**FINAL DRAINAGE REPORT
FOR
STERLING RANCH FILING NO. 2**

Engineering Review

**EPC Planning & Community
Development Department**

PCD File No. SF-20-015

RE: Sand Creek Wetland Memo
Sterling Ranch Residential Development Project
El Paso County, Colorado

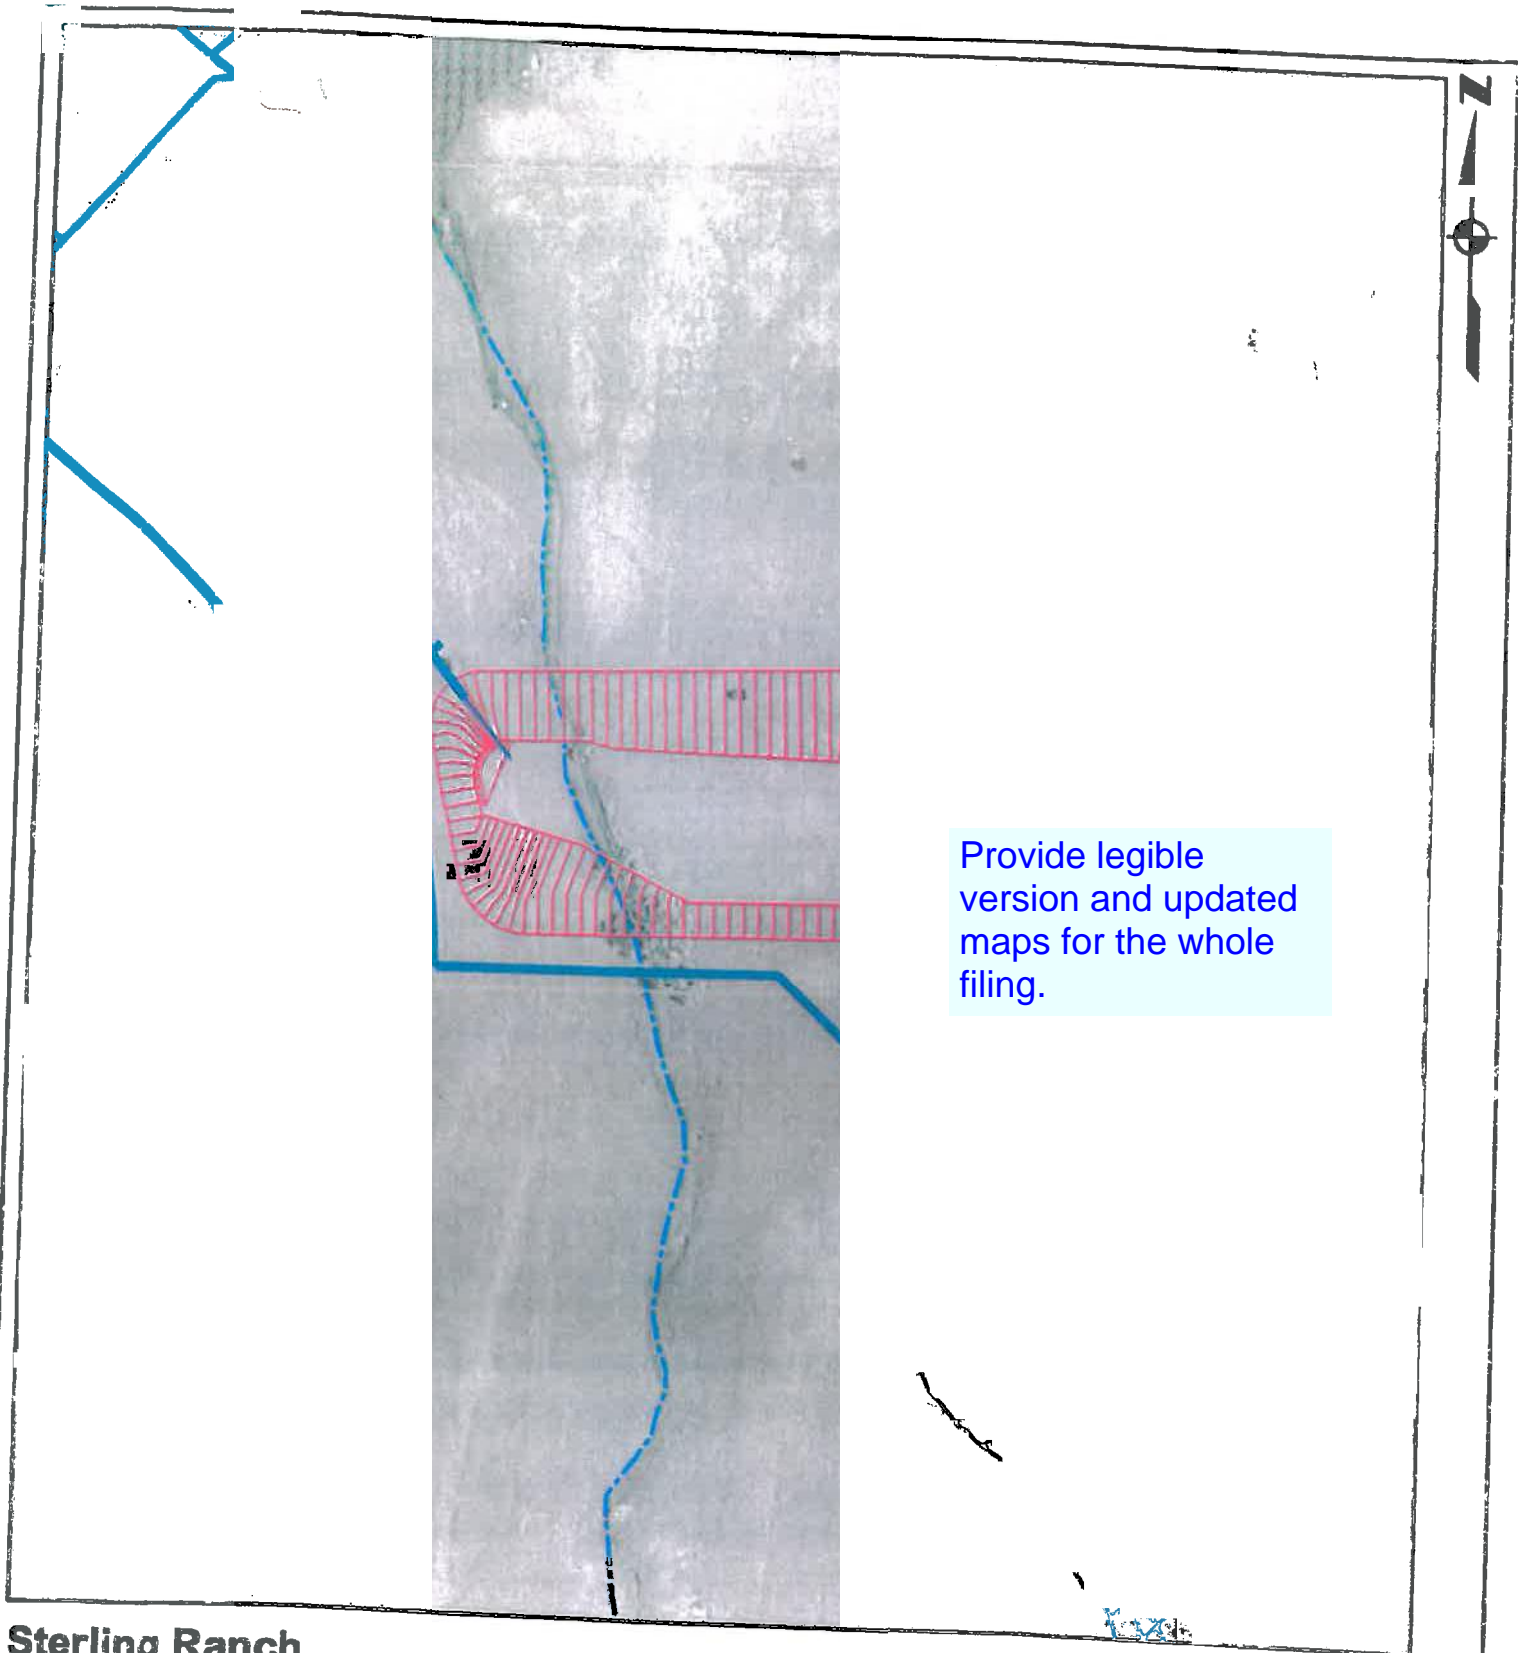
Provide legible version and updated maps for the whole filing.

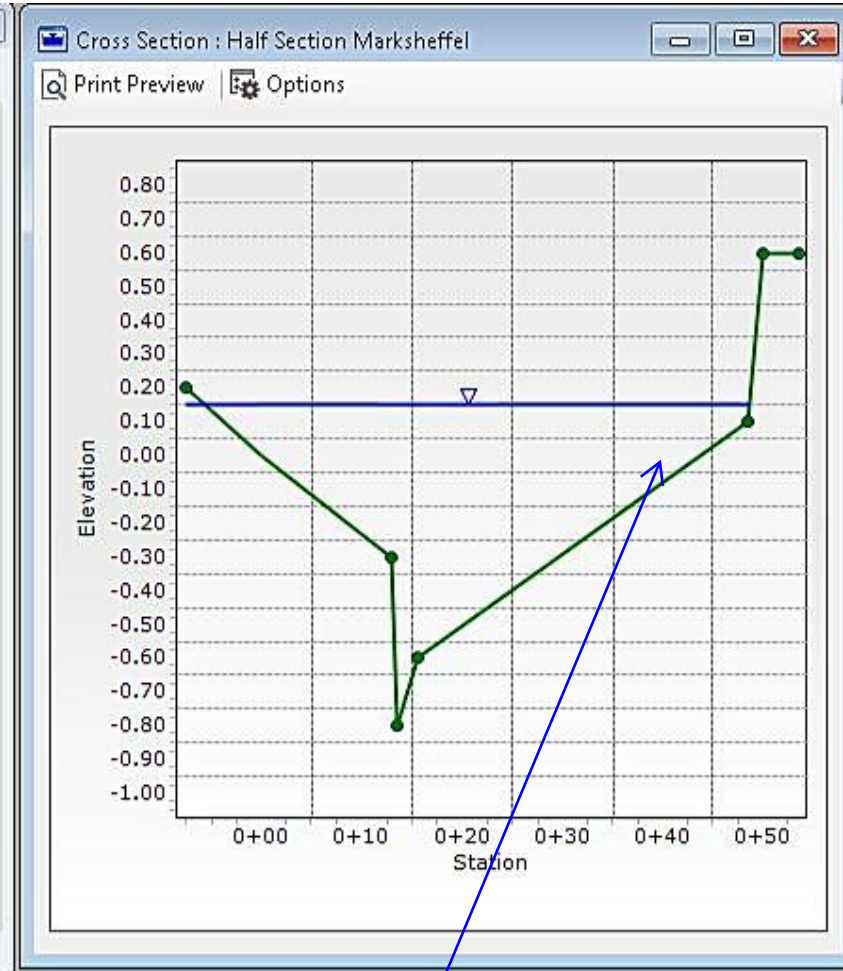
does this meet DCM1 criteria?

STERLING RANCH MDDP			
HISTORIC - DRAINAGE MAP			
PROJECT NO. 09-001	FILE: *dwg\Dev Plan\09001-MDDP HISTORIC	SCALE	DATE: 03/16/15
DESIGNED BY: VAS	CHECKED BY: VAS	HORIZ: 1"=500'	VERT: N/A
SHEET 1 OF 1			D1

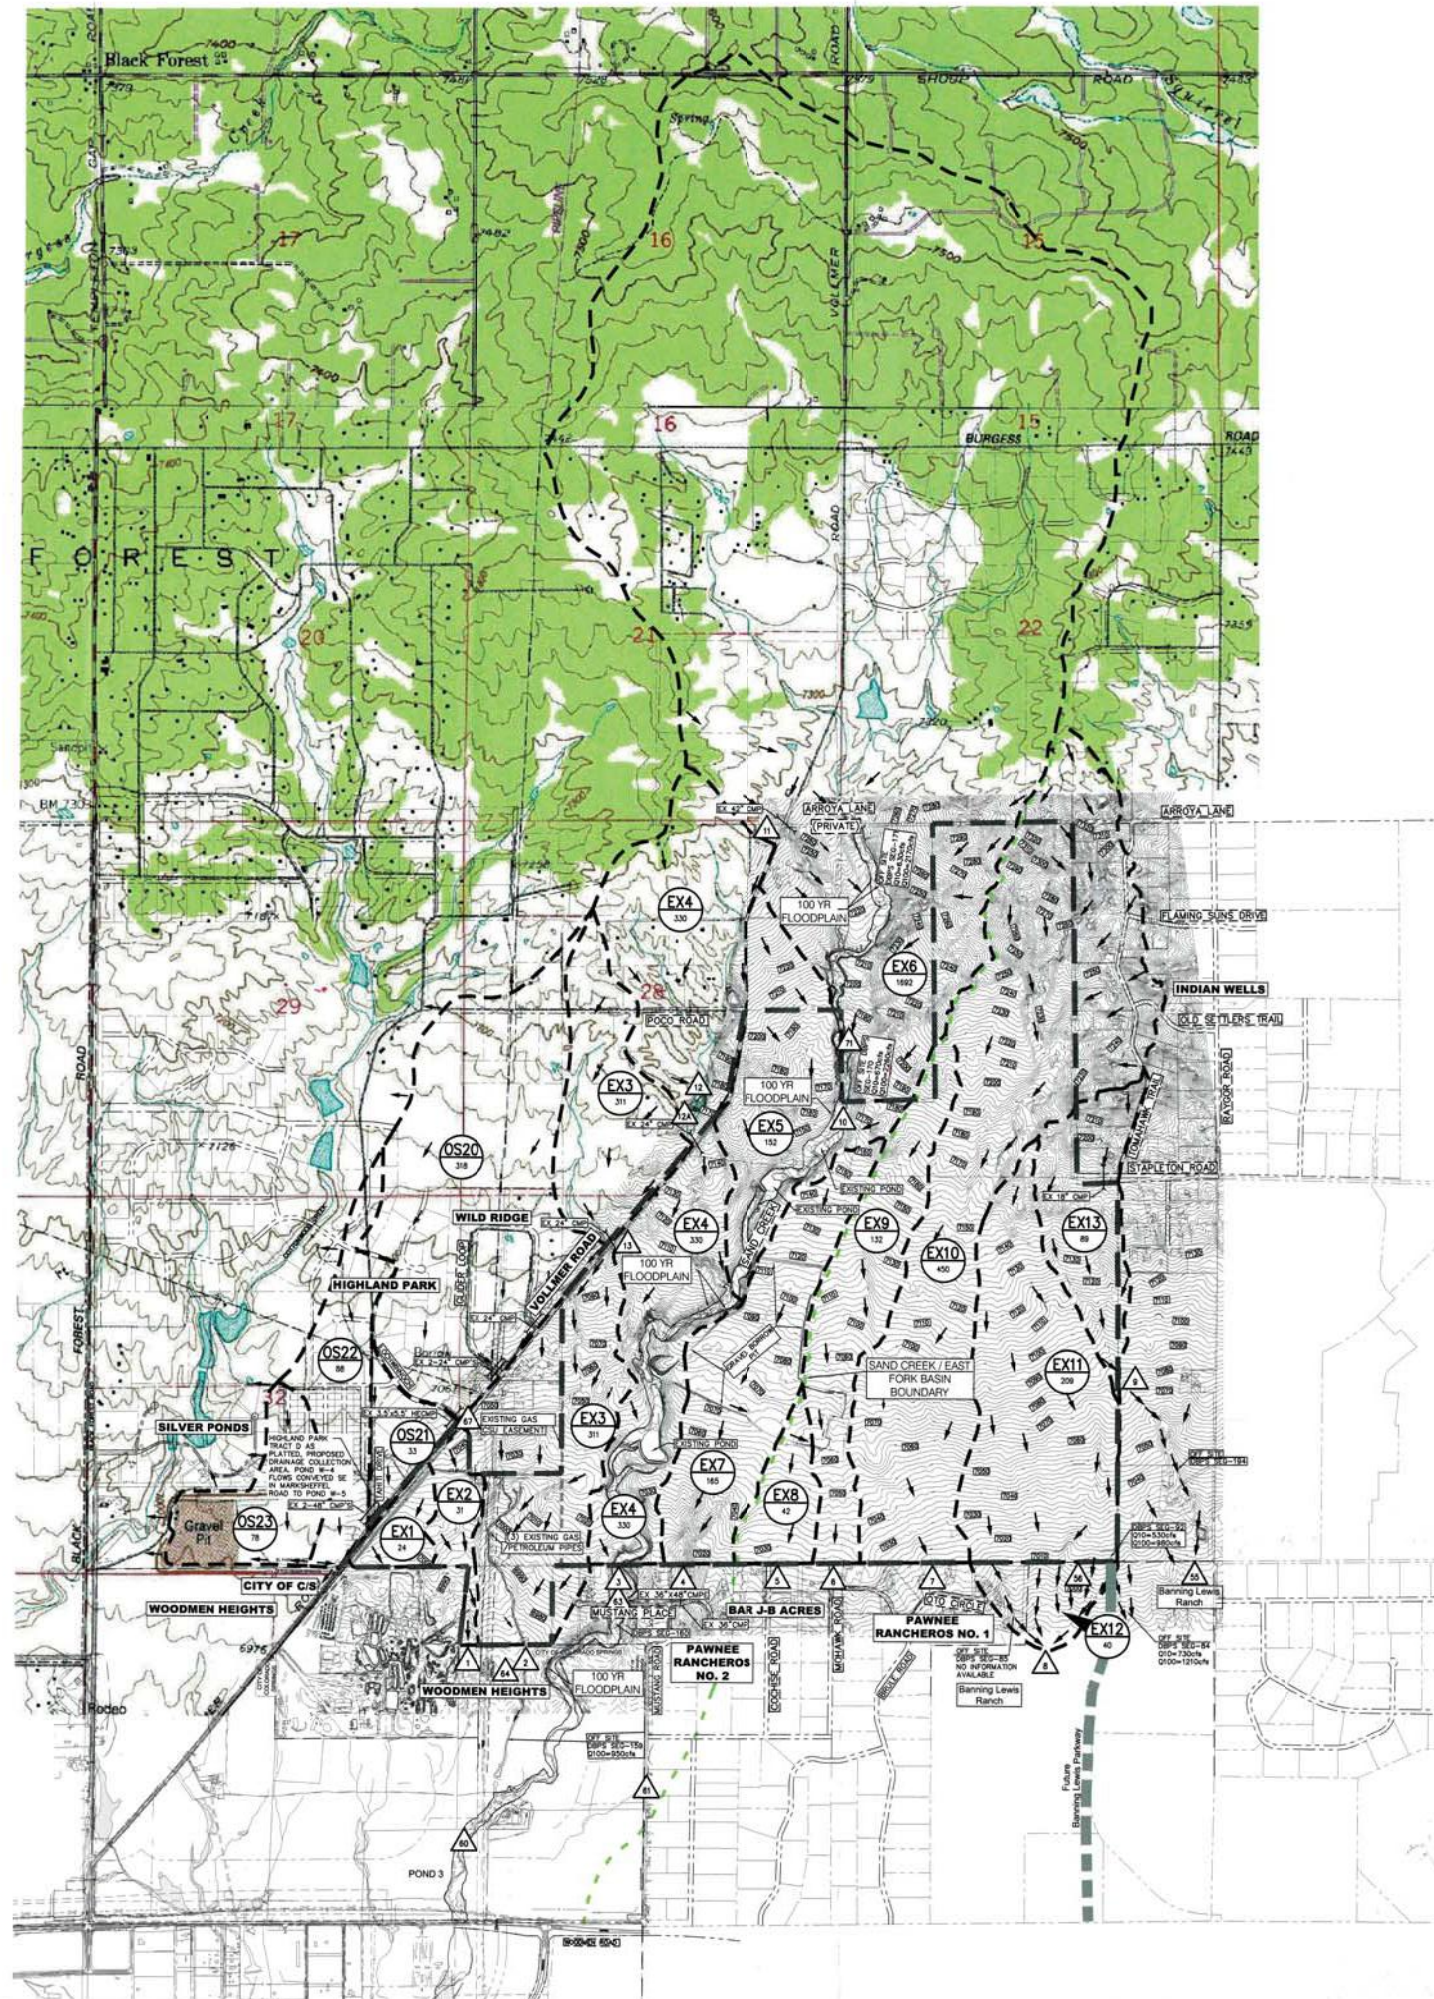
Provide developed condition MDDP map as well
